Addendum No. 2

Reference: CUCF W1 192 Bed Pod Expansion
Department of Corrections
DFCM Project No. 08231110

ADDENDUM NO. 2 to the Contract Documents for CUCF West Compound 192 Bed Secure Facility, Kennel and Intake Building in Gunnison, Utah

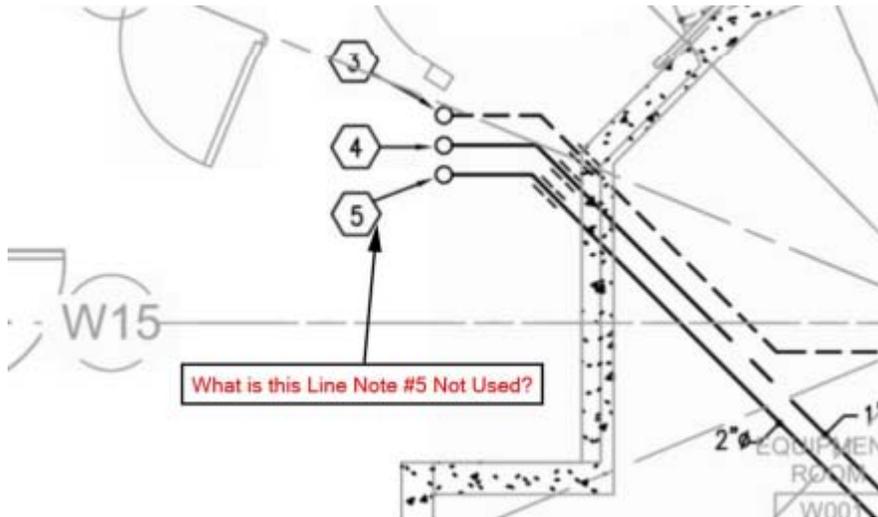
35.

Answer: Yes. It should be WC-4.

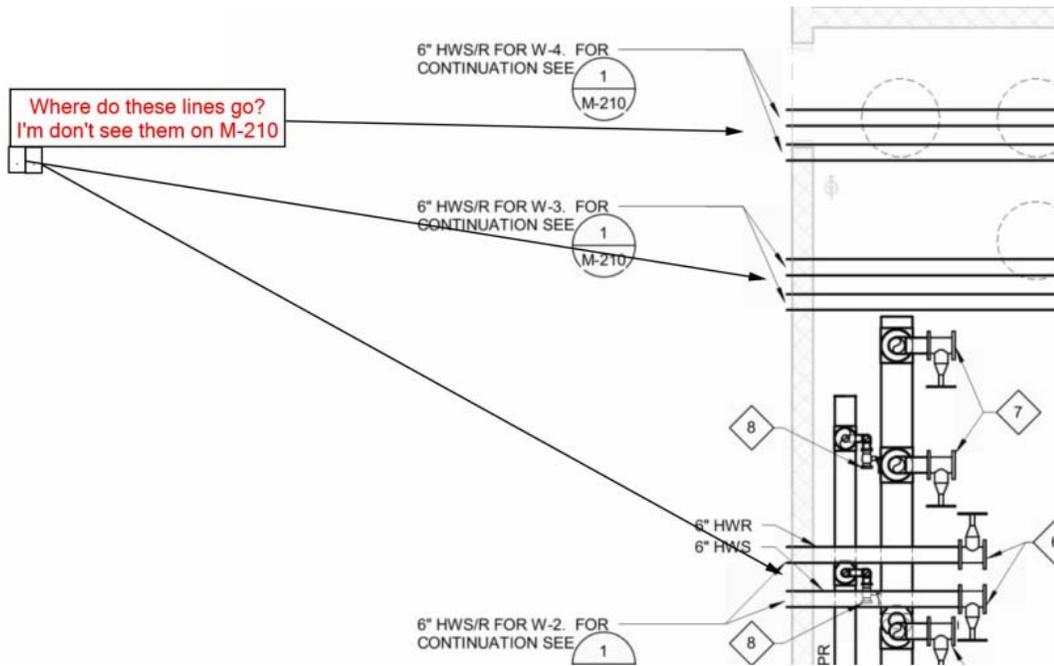
36.

Answer: Remove keynote 5 and associated piping. This is showing the fire sprinkler piping from the manifold in the mechanical penthouse down to the Lower Level Control Fire Hose Cabinet. This should be part of the fire protection drawings.

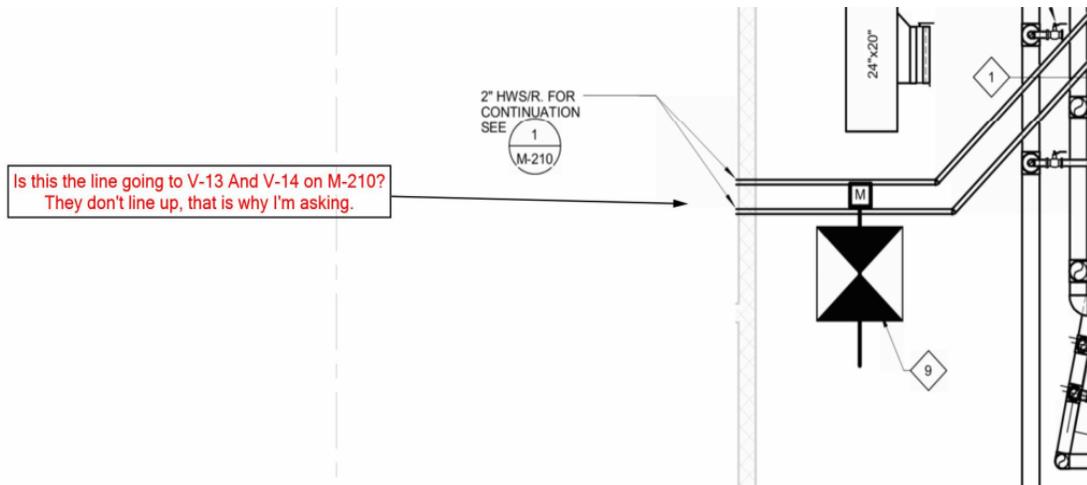
37.

Answer: Future heating hot water piping shall run above the ceiling of the Corr W146, and be capped for future.

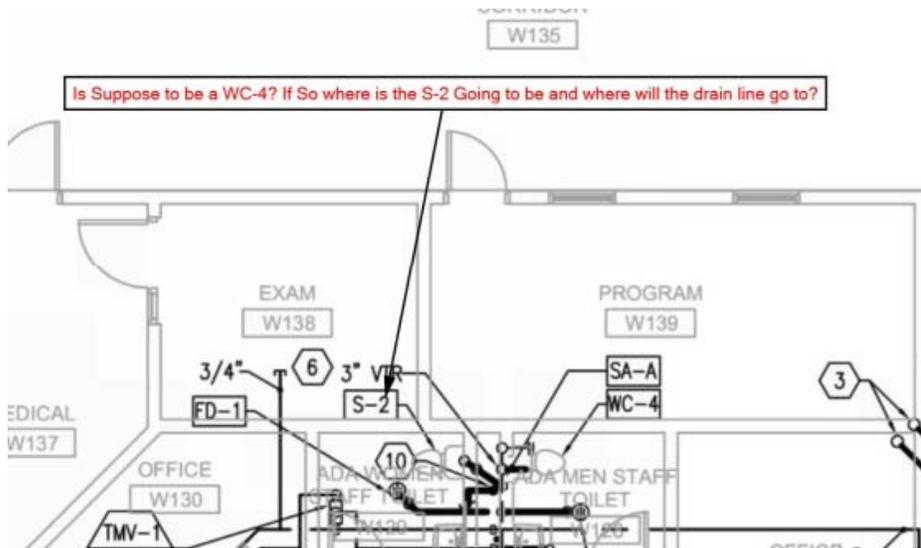
38.

Answer: The 2 -1/2" HWS/R is for V-13,14, and future hot water stub-out in Cart Storage W2032.

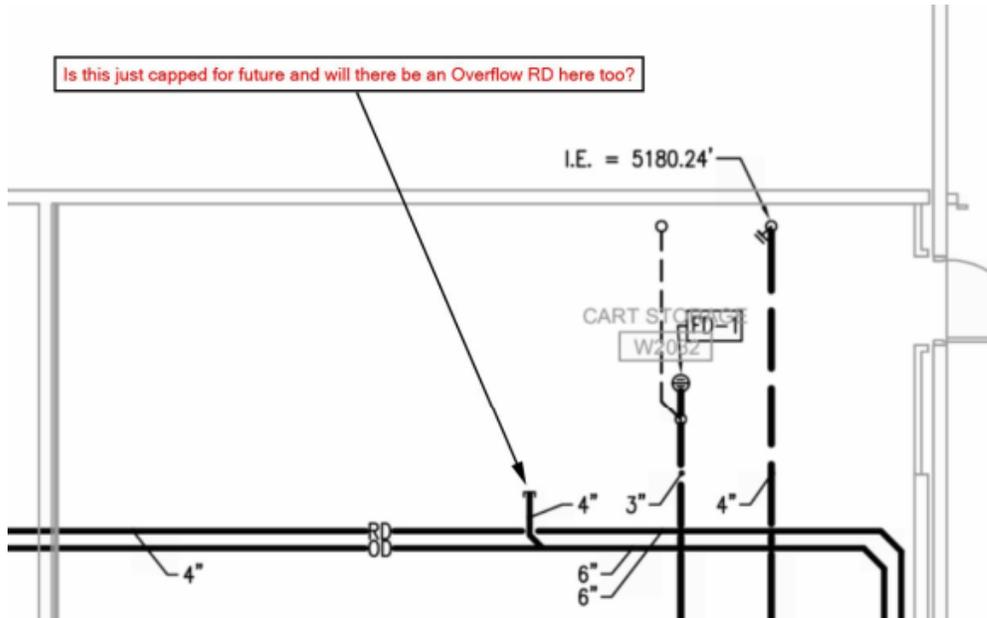
41.

Answer: There is no L-1 in that location.

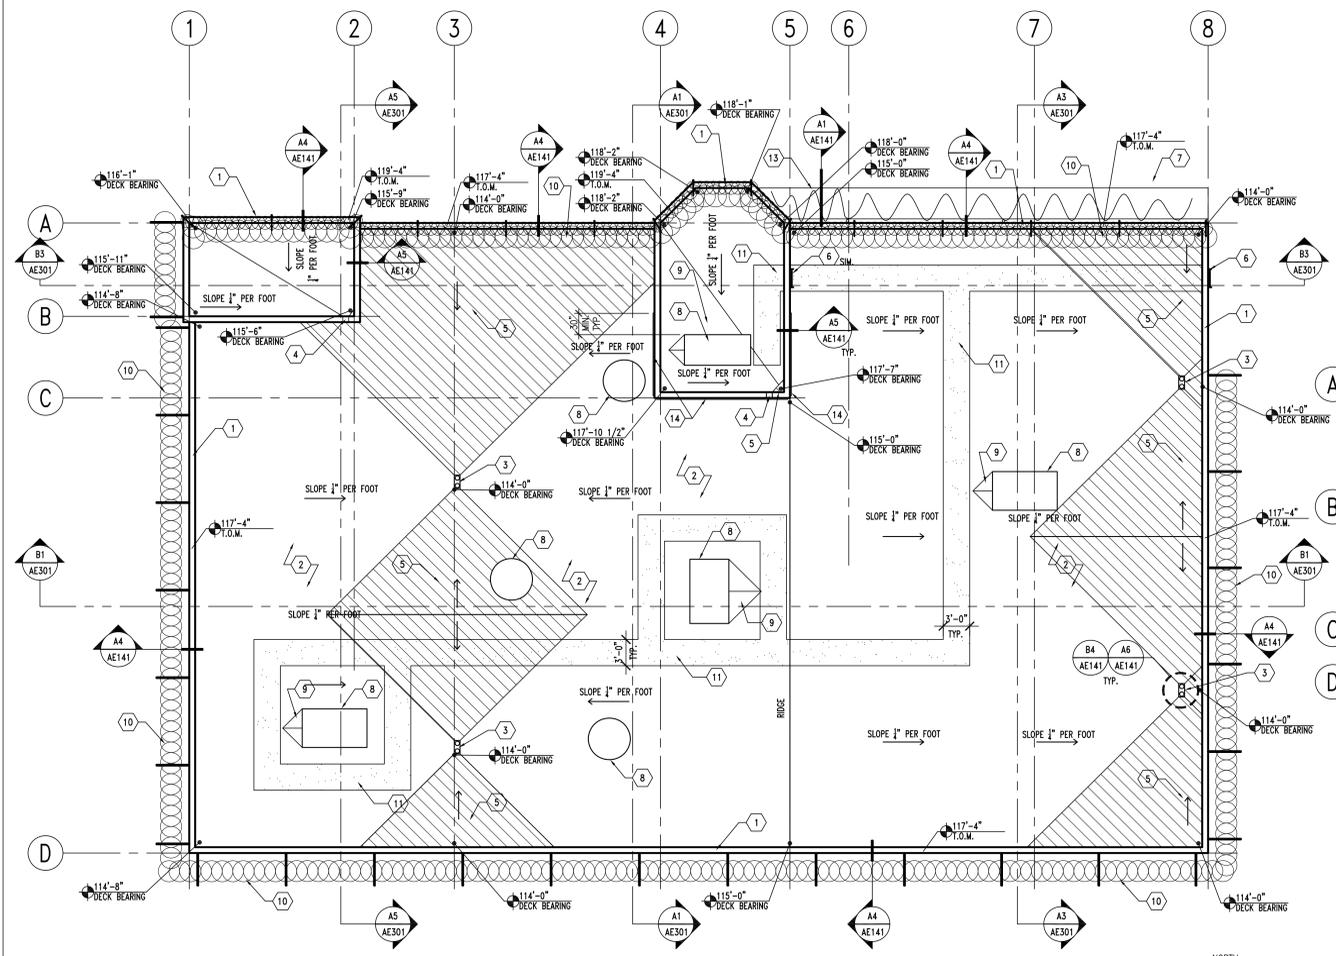
42.

Answer: Correct. This is a future capped overflow drain.

C4 KENNEL ROOF PLAN
AE141 REF. SCALE: 1/8" = 1'-0"

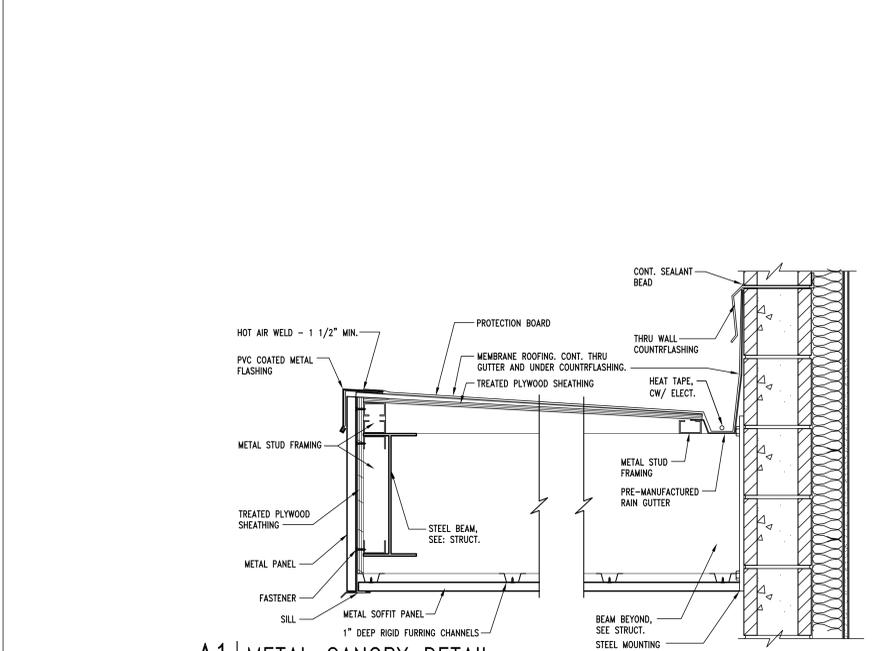
12. Please show the roof walkway pads that are called out on C4/AE141.?

Intake and Kennel Drawings, Sheet AE141:

- a. Drawing sheet has been modified in order to clarify walkway pads on Kennel Building roof. See attached drawing.

Answer: The location of the walking pads is being clarified through this addendum.

W1 HOUSING GROUND FLOOR PLAN - ELECTRICAL
SCALE: 1/4" = 1'-0"

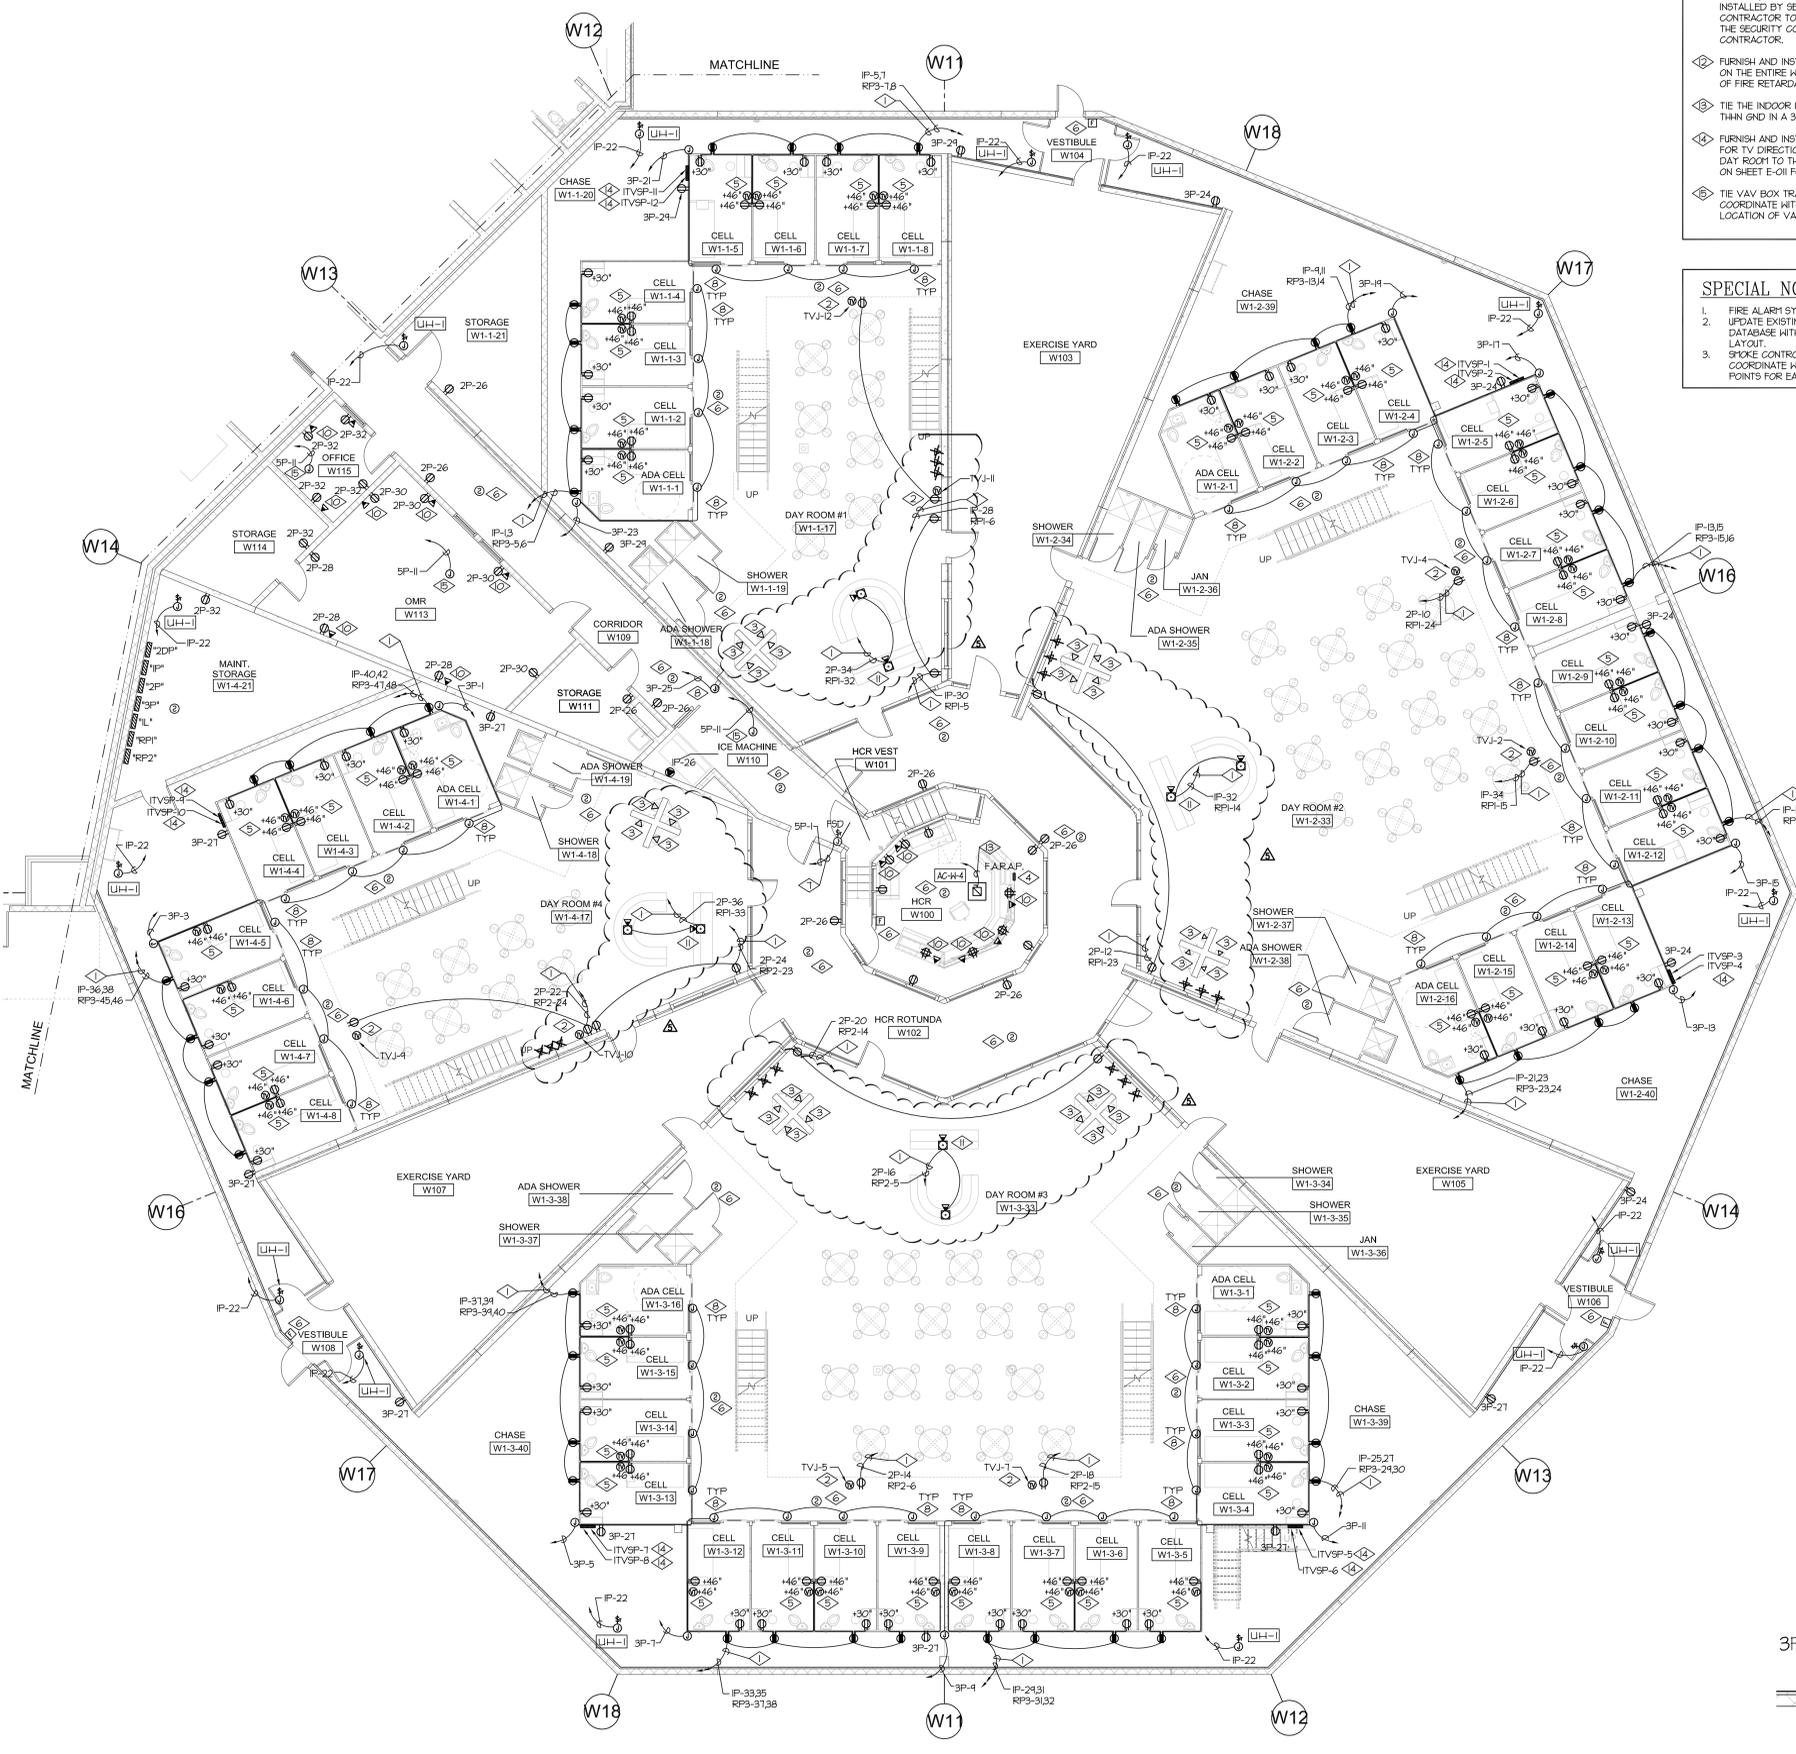
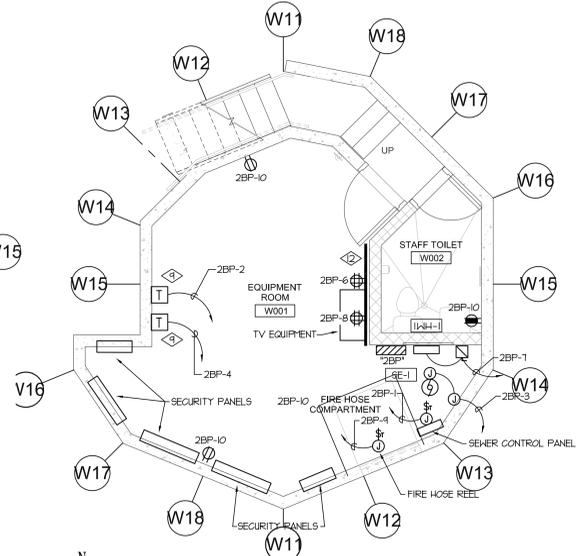
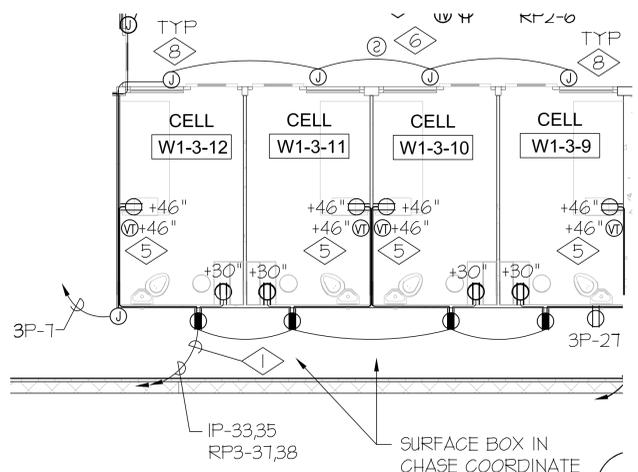
Sheet E-102:

- a. Change enlarged plans scale to 1/2" = 1'0".
- b. Day Room #1, #2, #3, and #4:

- i. Relocate the high security boxes for telephone to kiosks. Refer to attached drawing.
- ii. Add a high security floor outlet for power and voice/data under direct supervision station. Refer to attached drawing. Run a 3/4" conduit from each box to security panel in the basement. Coordinate with security contractor.
